A COMPANY OF THE SWATCH GROUP	Product Change Notification PCN	Nr. 180312-10 Publishing Date: March 21 st , 2018
--	--	--

Product information			
Item affected / Type	Tray for Holder SMTU2430-LF		
Part - Nr. (SAP)	701117	Drawing-Nr.	n/a

Foam tray change to PS tray SMTU/HU holder series

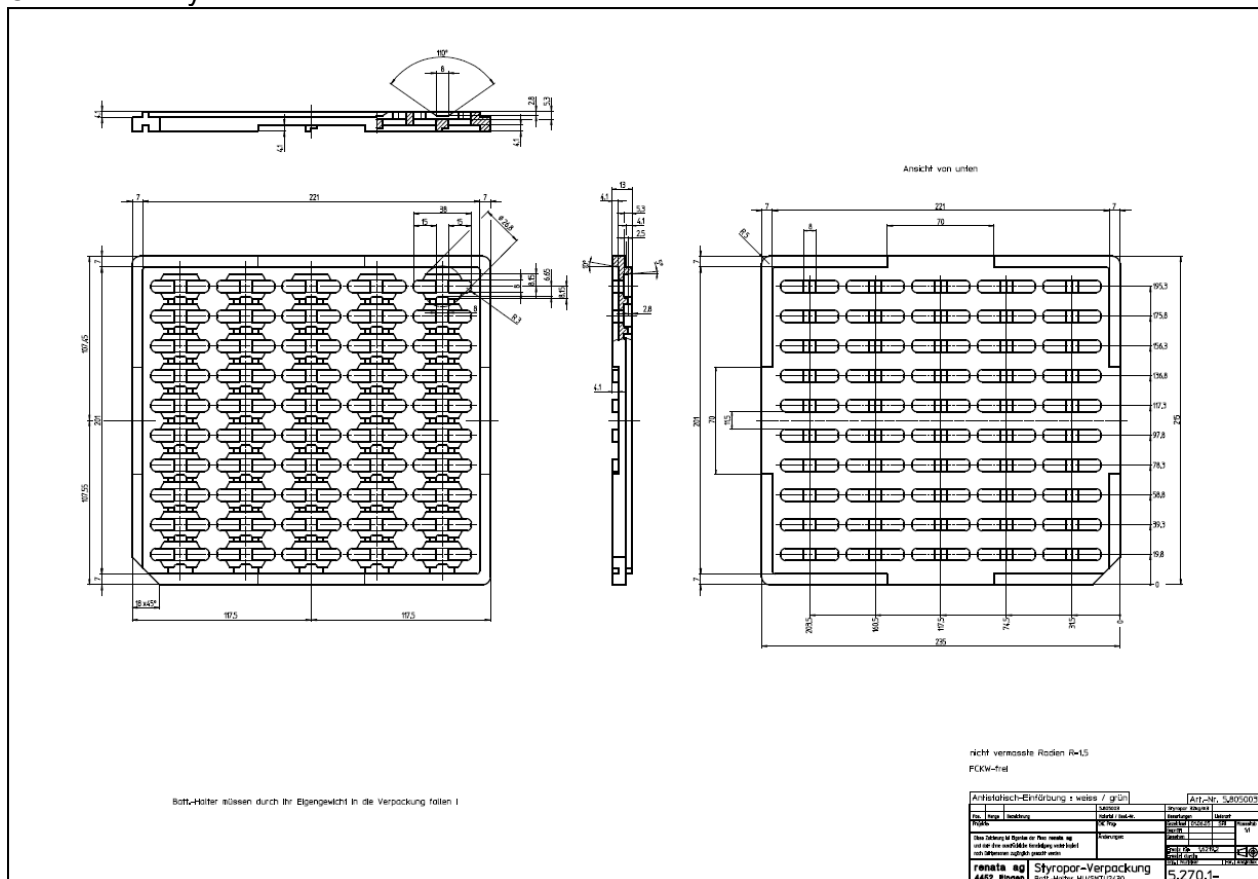
Product Change Notification	Description and reason of change
	Replacement of existing foam trays with PS (Polystyrene) material trays Drawing no. of Foam tray 5.270.1- Drawing no. of PS tray 5.439.2- Both drawing in attachment to compare. Same functions as PS tray Antistatic value: $10^3 \sim 10^6$ Quantities per Tray and also per shrinked pack will be kept unchanged. Placing of holders within in tray will remain unchanged Height of unit packing will be different. Current height for unit package foam tray: 109.0mm Estimate height for unit package PS trays 131.0mm Manufacturer part number will remain unchanged Change will be controlled by Lot number. Rolling change expected. Rollout of old tray expected to start in July 2019

Old Foam Tray

New PS Tray

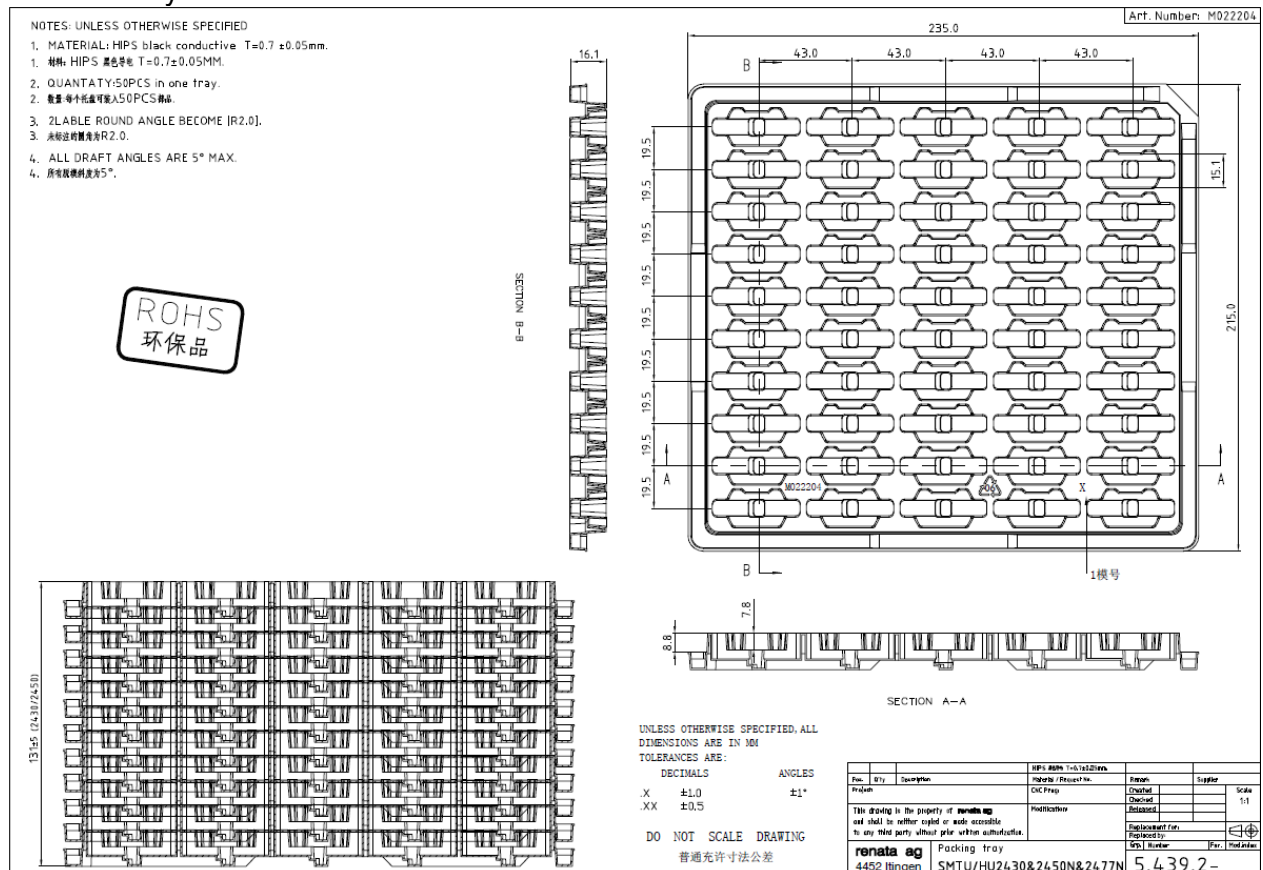
- NOTES: UNLESS OTHERWISE SPECIFIED
1. MATERIAL: HIPS black conductive T=0.7 ±0.05mm.
 1. 材料: HIPS 黑色导电 T=0.7±0.05MM.
 2. QUANTITY: 50PCS in one tray.
 2. 数量: 每个托盘装入50PCS产品.
 3. FLARE ROUND ANGLE BECOME [R2.0].
 3. 尖角此圆角变为R2.0.
 4. ALL FRAFT ANGLE ARE 5° MAX.
 4. 所有尖角均为5°.
